Process Sheet

: CU-DAR001 Dart Helicopters Services

: WELDMENT TOP PANEL

Subject: RE: D3650-3B Non-Conformance

D3650-3 CENTER PANEL

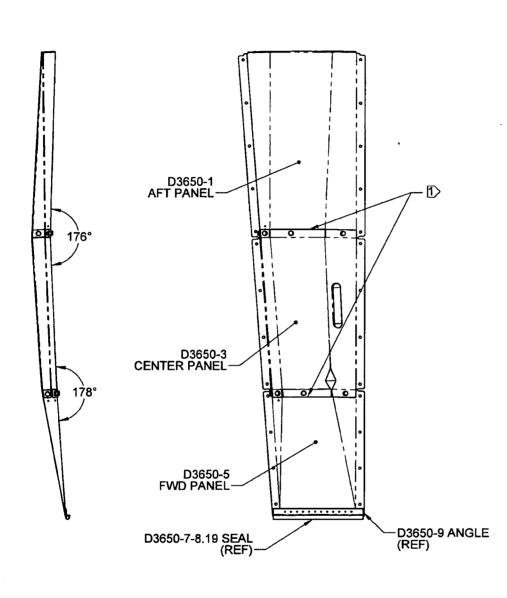
On D3650 drawing, P/N D3650-11 gets welded to D3650-3 Center Panel. We know that the weld bead must be grinded flush to D3650-3 but this is not indicated on the drawing.

Can you reply to this email and give your okay to grind the weld flush? Maybe we can update the W/O (or Estimate) and eventually update the drawing.

Yes is required to be grinded flush on the outside surface. May be for this DEO drawing will do.

D3650-3B CENTER PANEL BENT PART (MAKE FROM D3650-3F FLAT PATTERN)

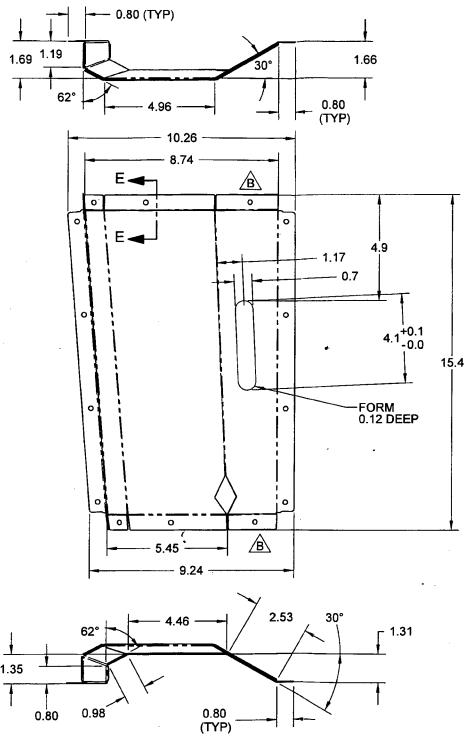
Awarting
revised cluy
from E.C.;
Roberto for
the PAR.

Eric Downing came to see me with a non-conformance on D3650-3B Center Panel Bent Part. The 4.1" +0.1"/-0.0" x 0.12" deep indentation measures 3.87" and is therefore 0.23" under tolerance. It turns out that the indentation was formed per tooling which also measures 3.87".

Regardless, the part does not measure up to the drawing. So the guestion is: is the indentation acceptable at 3.87" instead of 4.1"?

If it is not acceptable, we will have to raise a NCR and have Production manufacture a new tool. If it is acceptable, we will have to revise our drawing.

It is acceptable 3.87" instead of 4.1" for this time. Ensure FAI and tooling need to update to much the 4.1" shown in the D3650 Rev. B drawing.
